STAFF REPORT

SUBJECT:	PRS 21-0064	PLANNING AREA:	Brandon
REQUEST:	Minor Modification to an Approved PD	SECTOR	Central
APPLICANT:	Galencare, Inc.		
Existing Zoning: PD 97-0121 (PRS 19-1247)		Comp Plan Category:	P/QP

APPLICATION: PRS 21-0064 ZHM HEARING DATE: n/a

Exhibit 2: Existing Site Plan (PRS 19-1247) Exhibit 3: Proposed Site Plan (PRS 21-0064)

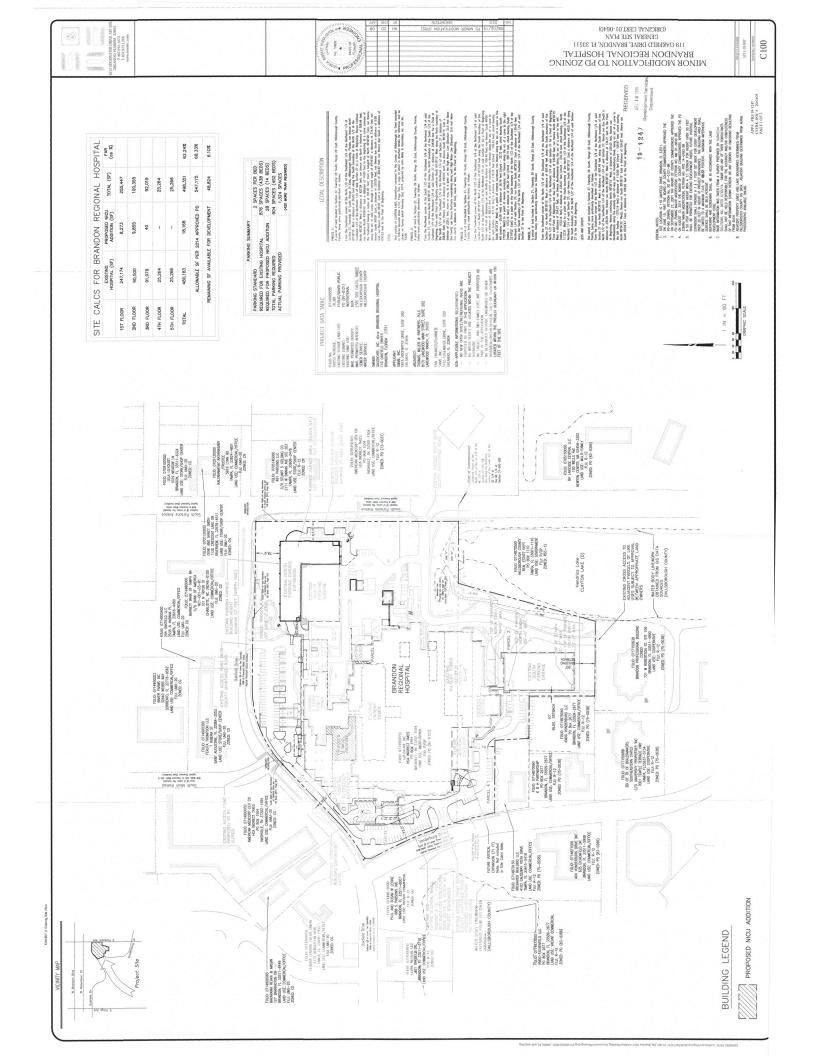
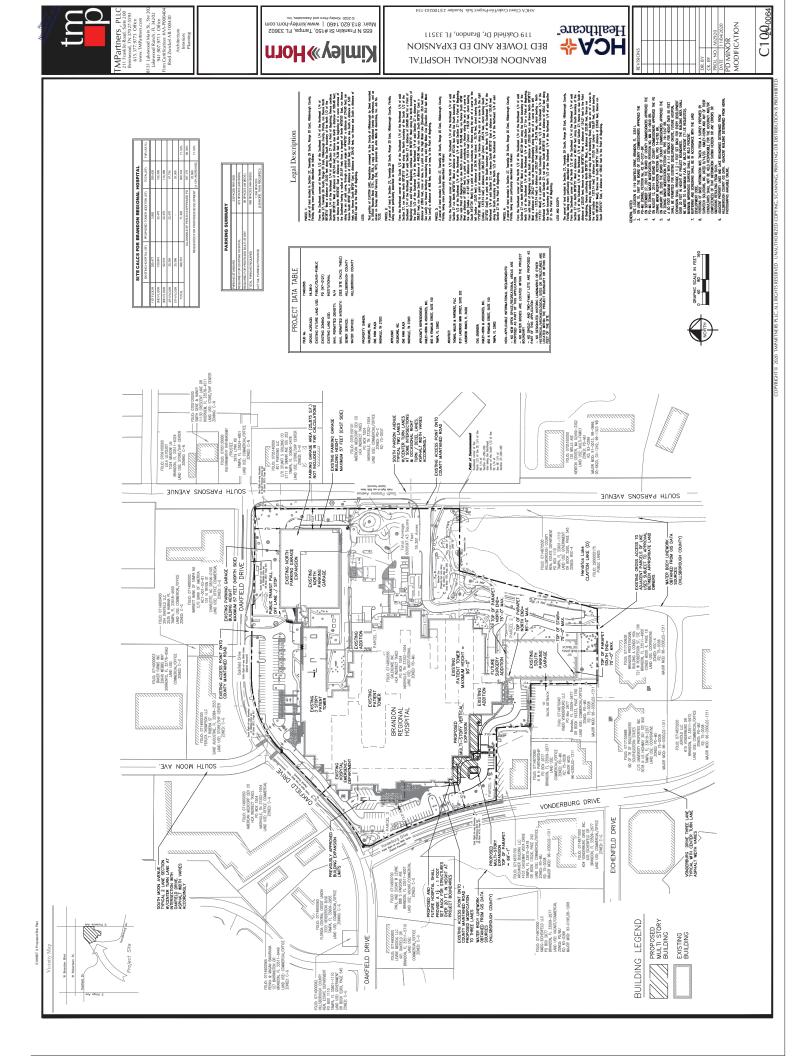
- To increase the gross floor area from 547,175 square feet to 569,744 square feet (4.12% increase).
- To reduce the southern setback from 84.7 feet to 58.4 feet for the proposed multistory vertical expansion.

The applicant has submitted a revised General Site plan to reflect the requested changes.

1. Denote the "Top of Stair=75' max." for the stairwell in the proposed multi-story vertical expansion area
